Project Name:	Land at Bayards, Eastergate (Miller Homes)
Document Reference:	091.5016/SVR/3.2
Document Name:	SuDS Verification Report – Area 3
Prepared By:	Samuel Flesher
Checked By:	Meagan Weedon
Approved By:	Jon Soar

Revision Record				
Rev	Date	By	Summary of Changes	Aprvd
1	30/04/2026	SF	First issue (Draft)	MDW
2	01/05/2026	MDW	Second Issue	JFS

- 1.1 This Sustainable urban Drainage Strategy (SuDS) Verification Report – Area 3, has been prepared by Paul Basham Associates on behalf of Miller Homes to support the 'As-Built' verification report to Arun District Council in relation to Land at Bayards, Eastergate.

Figure 3: SDS GEOLight Cross Section

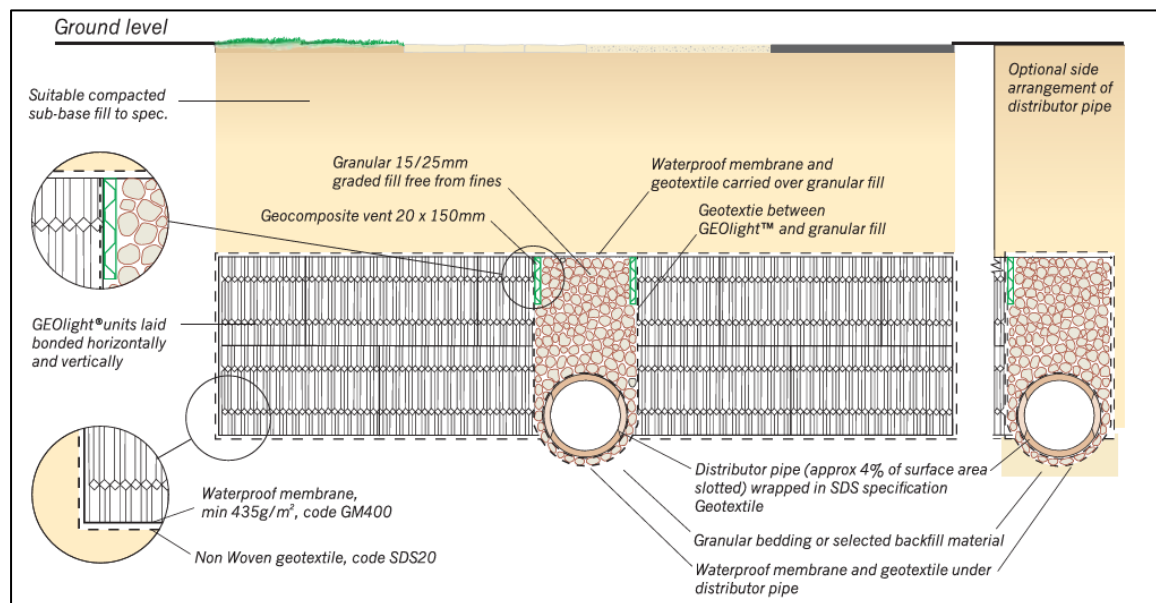
- 4.8 Plots 48, 49 & 51 have shown an arrangement that differs from the design outlined within the construction detail on sheet 091.5061.551 C01, this is likely due to the use of the SDS GEOLight. This product typically requires a specific arrangement, including a perforated pipe running centrally through the attenuation crates, as illustrated in **Figure 3** below. However, the contractor has instead installed an in-situ pipe that has been hand-cut with spiral slits to function as a perforated pipe, intended to feed water into the crates. This pipe appears to have been installed without appropriate bedding. Furthermore, the structural integrity of the pipe has likely been compromised due to the hand-cut slits, which is also evident from the CCTV footage. There also appears to be no restraint preventing the pipe from shifting or rotating. As a result, there is no assurance that the slits will remain correctly oriented (i.e. facing downward towards the crates).

- 4.9 This may lead to ineffective interaction between the pipe and the attenuation system, potentially causing the drainage to perform in an unintended and unpredictable manner.

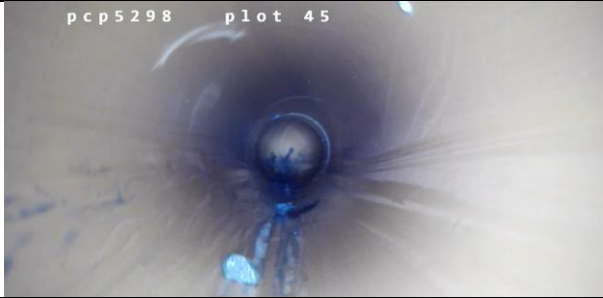
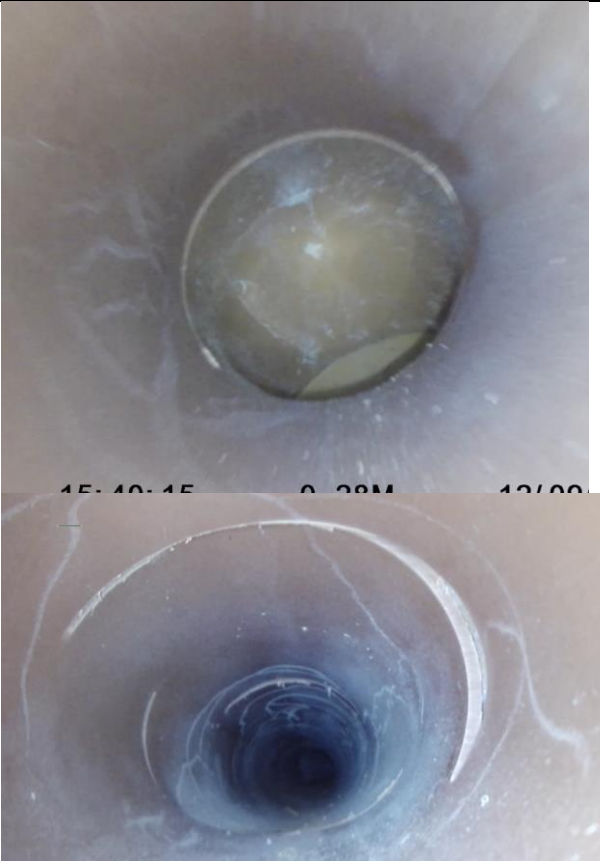
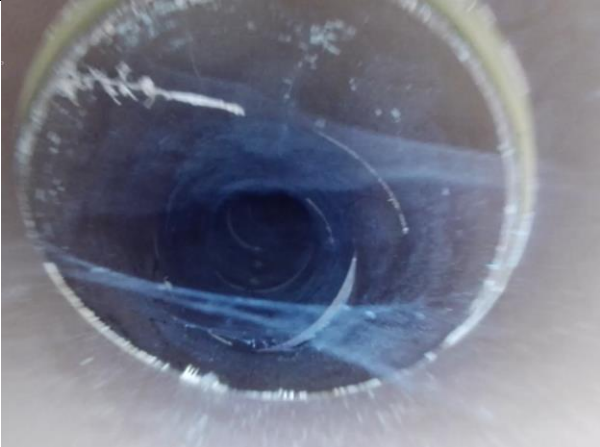
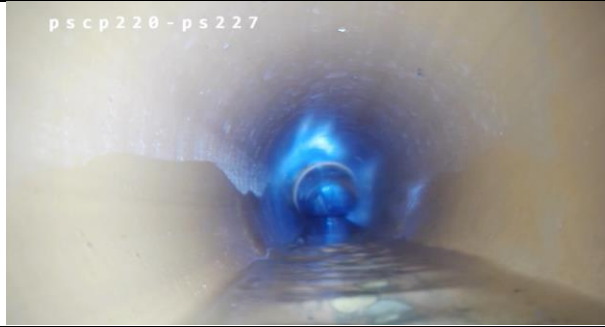
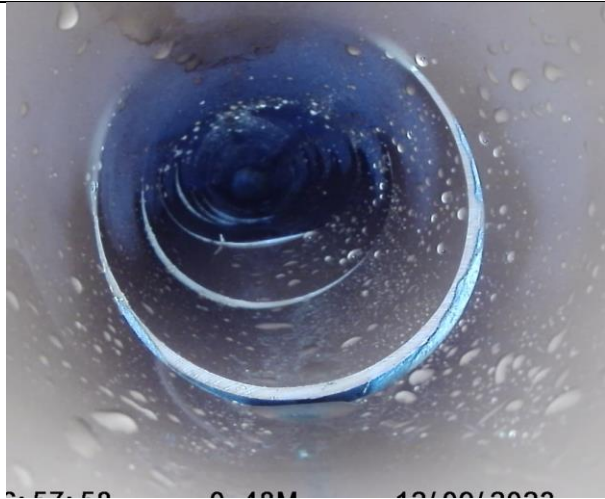
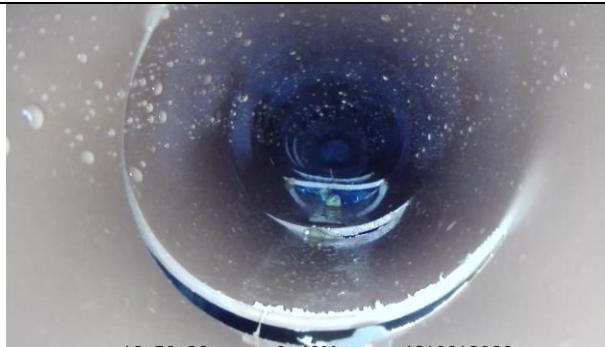
Ref	Defect Images	Comments
S26-S5		S26 Depth 1.35m As Built Depth 1.31m Video terminates at 19.60m Design length 22.48m No Defects present
S5-S6		Depth 1.5m As Built depth 1.38m Longitudinal cracking present at 7.95m Video terminates at 12.48m Design length 16.809m Downstream defender does not appear to have been installed in S6
S6-SA Road 2	No footage provided	
RE5721-PS235		No depth given in video, Video starts at 9.89m video ends at 3.17m Design length: 11.011 No junctions for RWP were visible in survey No defects
PS235-PSCP236		No defects
PSCP236-SA38-39	No footage provided	
PS243/PS5297-PSCP240		Standing water at start of survey- suggests the pipe is back falling
RWP-PSCP240		Video starts at 3.17m No Defects

PSCP240-SA38/39		Semi spiral cuts present on the video, causing the pipe to bend. Pipe also not cleaned after being cut and signs of debris from cuts present. CCTV survey shows the pipe is back falling.
PS243-PSCP249		Video labelled as Plot 40 RWP, suggesting that the RWP is connected directly into PSCP249 and that PS243 chamber was not constructed. Standing water present in pipe downstream, unclear if this was due to poor drainage or recent weather, no recent weather was provided.
RWP (Plot 41) – PSCP249		View blocked by obstruction but appears to be no defects.
PS248-PSCP249		Survey appears to terminate at a bend suggesting that PS248 chamber was not installed.
PSCP249-SA40-42		No defects
PS5272-PS253		Unclear if full length of sewer was surveyed as upstream manhole could not be seen No defects
PS253-PSCP254		No defects
PSCP254-PS3301		No Defects
PS3301-SA43-45		damage to infiltration crates has been caused due to inadequate connection. No defects within pipe

PS5285- PSCP298		Bend encountered, Chamber PS5285 does not appear to have been constructed.
PSCP298- PS5299		Large amounts of sediment build up, PS5299 looks to have been built as a catchpit manhole unclear if there are two catchpit manholes or PS5299 is the sole catchpit on the network.
PS5299-SA43- SA45		Pipe appears to change direction of slope, at ~1.5m into survey. The pipe appears to terminate above infiltration crates.
RWP (Plot 48) – PSCP330		RWP looks to have not been properly connected. No defects within pipe sediment build up could suggest pipe has been laid at a shallow gradient.

PSCP330-SA48		Pipe appears to change direction twice and spiral slits have been cut into pipe. From the images in section 4.4 there is two pipes coming into the crate system, the other pipe will need to be surveyed and a catchpit manhole must be installed upstream of this pipe.
PS334-PSCP335		Standing water and large amounts of sediment build up in PS334. Water does not appear to be flowing downstream suggesting that the pipe is back falling
PSCP335-SA49		Pipe displacements, deformed pipe due to spiral section cut through the pipe. Pipe appears to have moved away from joint in image.

PS5270-PS227		Small amount of water present in PS227
PS227-PSCP228	Survey not recieved	
PSCP228-SA51		Pipe displacements due to spiral cuts in pipe, pipe has changed direction due to settlement.
PS5283-PSCP231		No defects
PSCP231-SA52		Pipe displacements due to spiral cuts in pipe.

- 7.5 The remedial works required within Area 3 is as listed below:
- The Contractor shall obtain written approval from crate supplier that the constructed soakaways comply with their specification. Notwithstanding this requirement, it is recommended that all damaged or deformed pipes be removed and replaced.

- Install additional infiltration crates where the storage volume is less than what was specified in the approved design or provide supporting hydraulic modelling to support the as-built storage.

- Once remedial works have been carried out the system will need to be re CCTV surveyed.

PBA Drawing No. 091.5016.0501 Revision C08

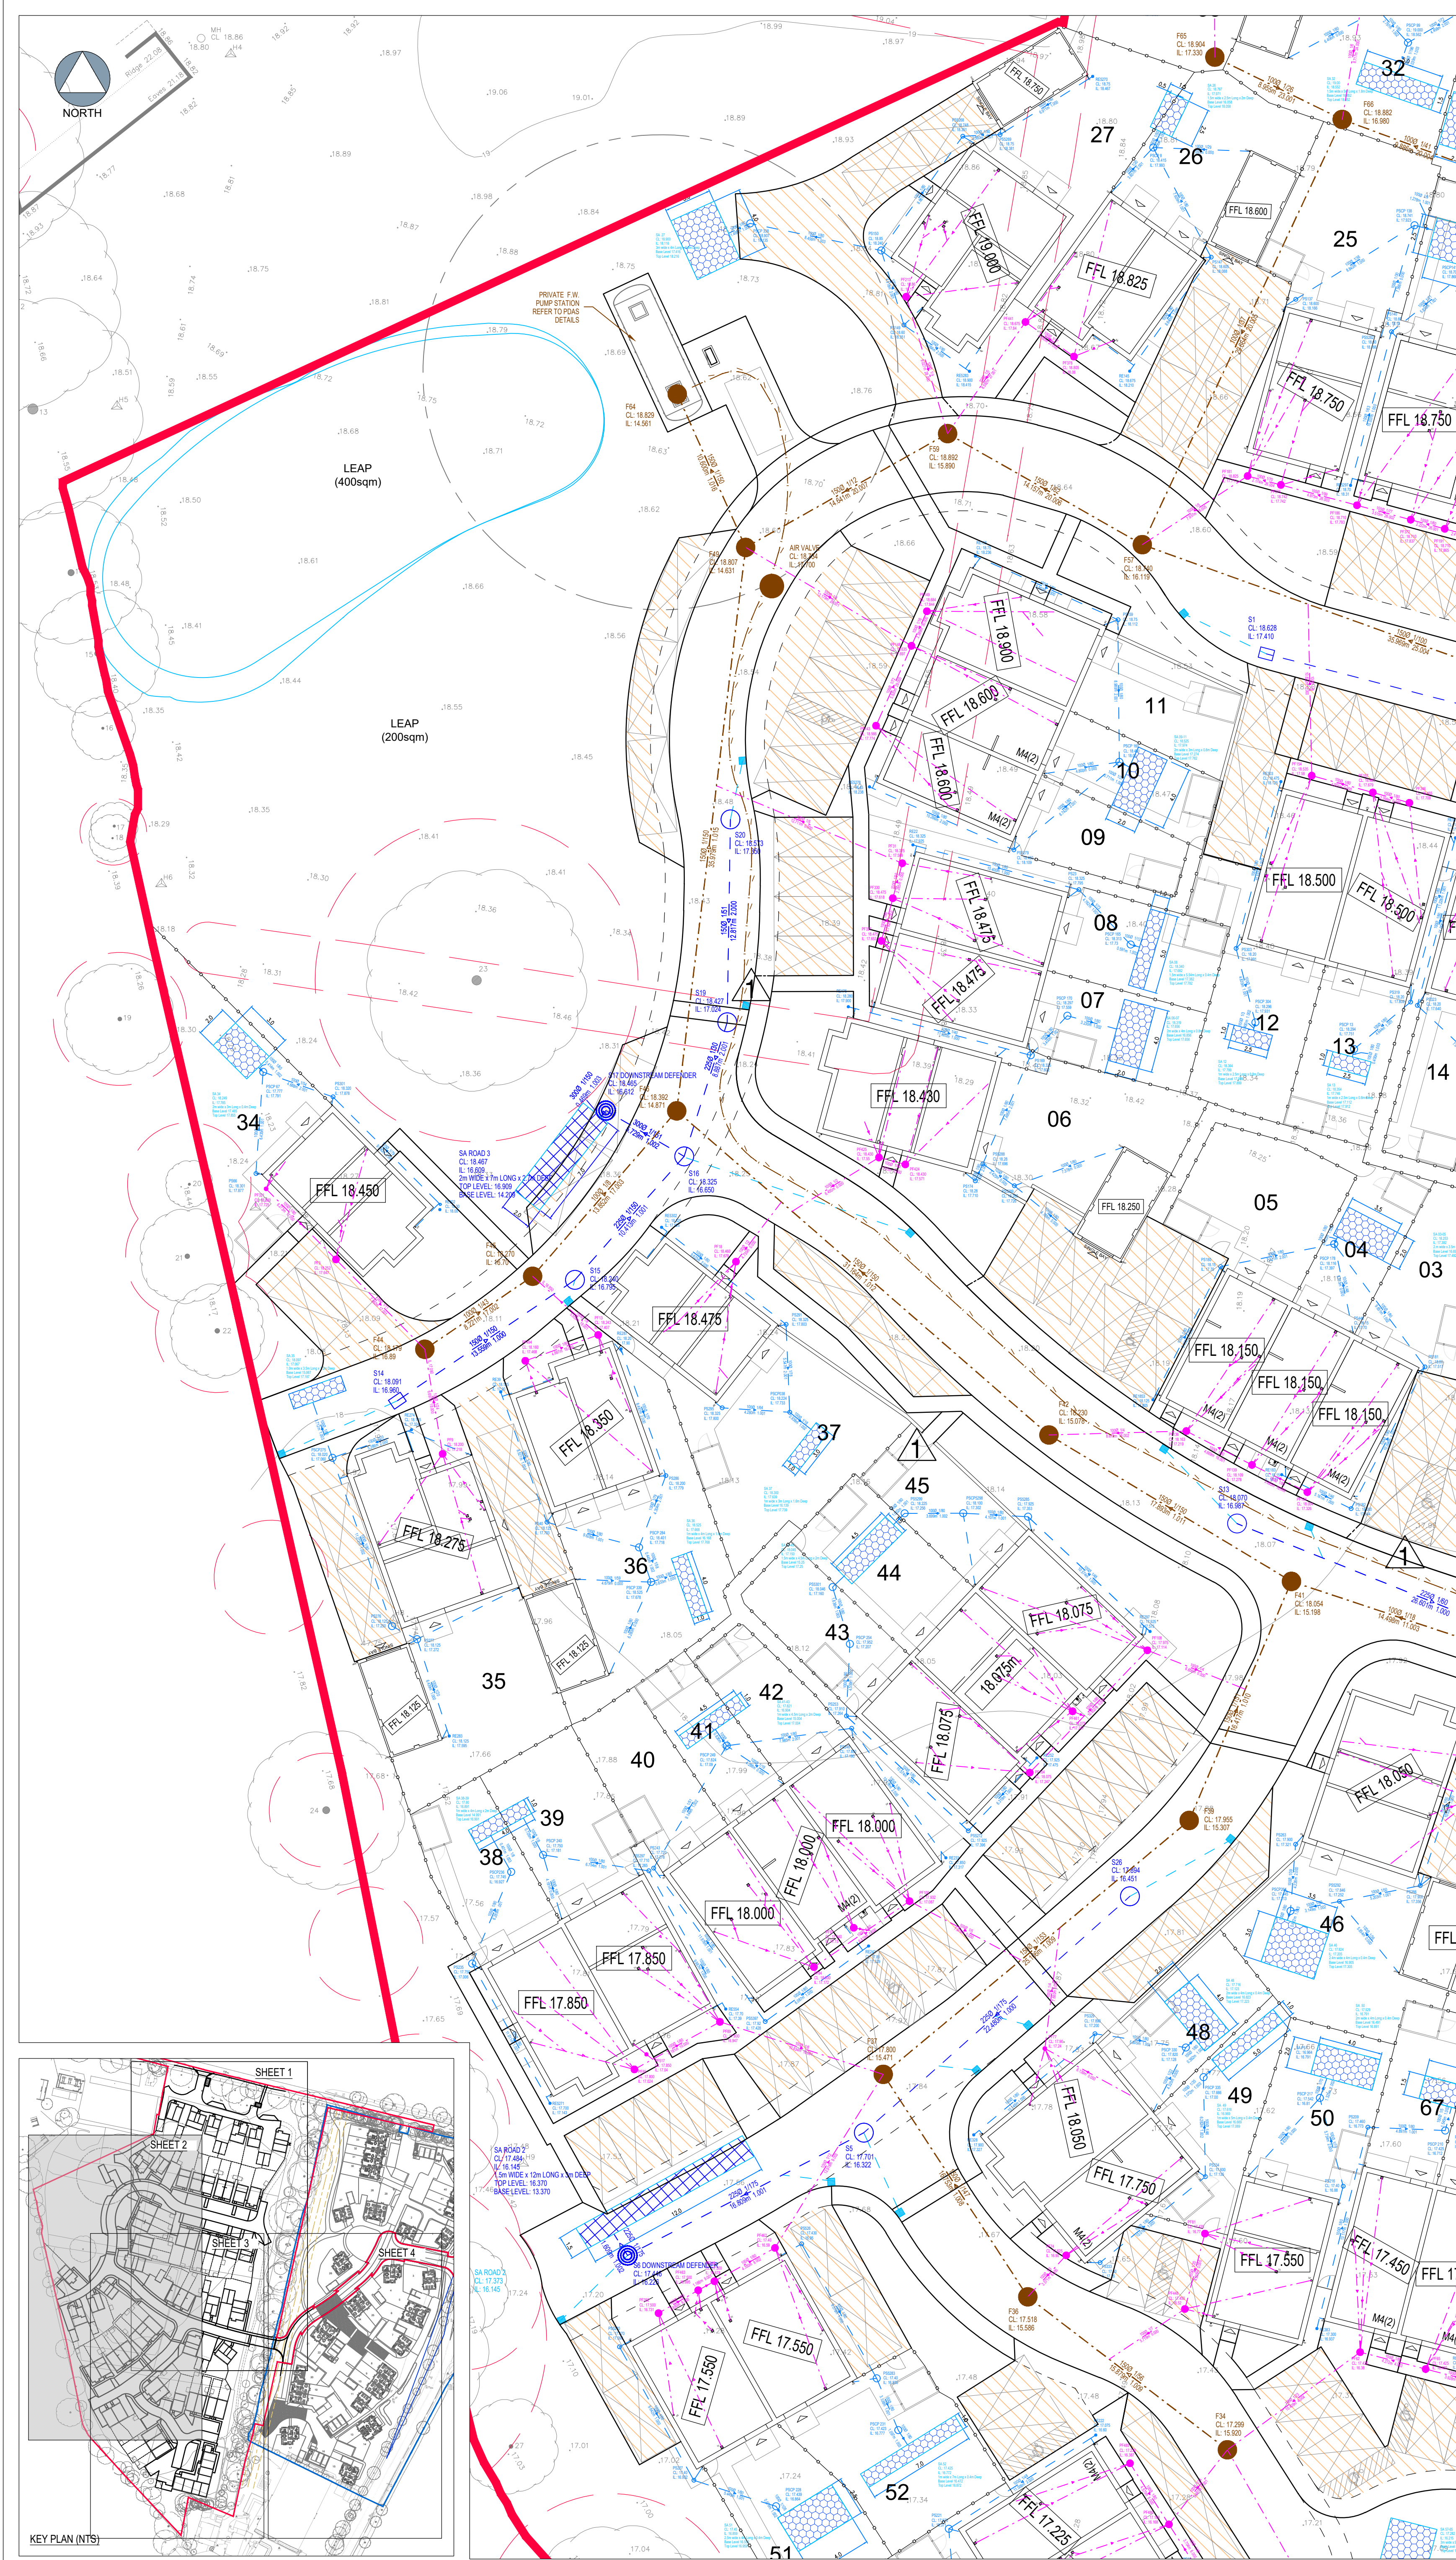
- 3.1 As-Built surveys of the site area and drainage systems have been carried out, these surveys are included as **Appendix C**
- 3.2 These levels have been reviewed against the design levels shown in 091.5016.0501 C08, 091.5016.0502 C05 and 092.5016.0503 C06 the design drawings can be found in **Appendix B**
- 3.3 A tabulated summary of invert levels for chambers constructed within Area 3 is given below.

- 3.4 The comparison between the design and as built levels shown that the invert levels are generally within normal building site tolerances and fall in the correct directions, unless otherwise noted within the comments provided in Table 1 above.
- 3.5 Based on the as-built levels as per Table 1 cross checks of raised invert levels appear to show that no backfalls have been created.
- 3.6 No levels were provided for RE233.
